| Intersection ID: 13413 | Main Street: OLD_STEELE_CREEK_RD | Cross Street: SEYMOUR_DR | Location: | NW |
| ADA ID: 9222F5A364DC | Ramp Type: ParaDiag | Initial Pass/Fail: Fail | Overall Compliance: No | Severity Score: 13.75 |

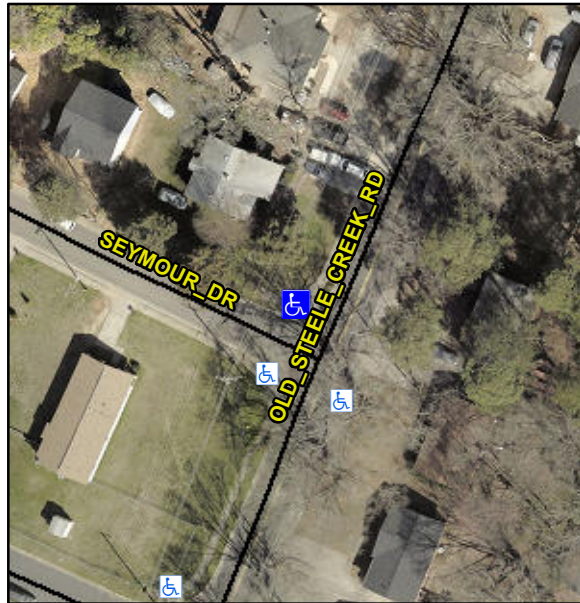
Surveyor Notes:

LT RP < 5%

PROW/ADA:

R304.3.2, R304.5.3

| Compliance | Description | Data | Compliance | Description | Data |
|------------|----------------------|-------|------------|-----------------------------|-------|
| Yes | Ramp Slope LT (%) | 2.8 | No | Ramp Slope RT (%) | 8.7 |
| Yes | Ramp XSlope LT (%) | 1.4 | No | Ramp XSlope RT (%) | 2.3 |

Possible Solutions:

Remove & Replace Curb Ramp With Two New Directional Ramps or Equivalent.
